Individual Comment
Letters and Responses
on the Draft EIS/EIR
for the
Van Ness Avenue
Bus Rapid Transit Project

APPENDIX I

Individual Comment Letters and Responses

RAMP TO BUS

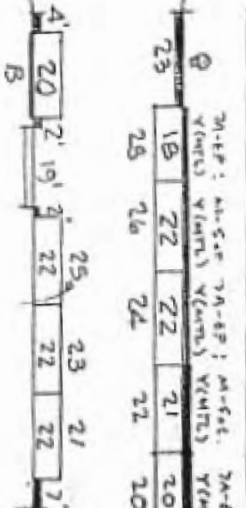
This would help the bus move faster and open more loading dock hours to better park. No more getting the money parked by and get stuck in the money park. Also more all also save the money.

I-18-I	Each of the BRT build alternatives, including the LPA, would offer level or near level boarding for passengers (including those in wheelchairs or with baby strollers) to board and alight the bus with ease. Ramps would not be needed. As stated in Section 3.5.3, the SFMTA will give priority to retaining color-painted, on-street parking spaces, such as loading zones on street blocks where parking would be removed. All blue handicapped parking spaces will be designed to provide a curb ramp behind each space.
--------	---
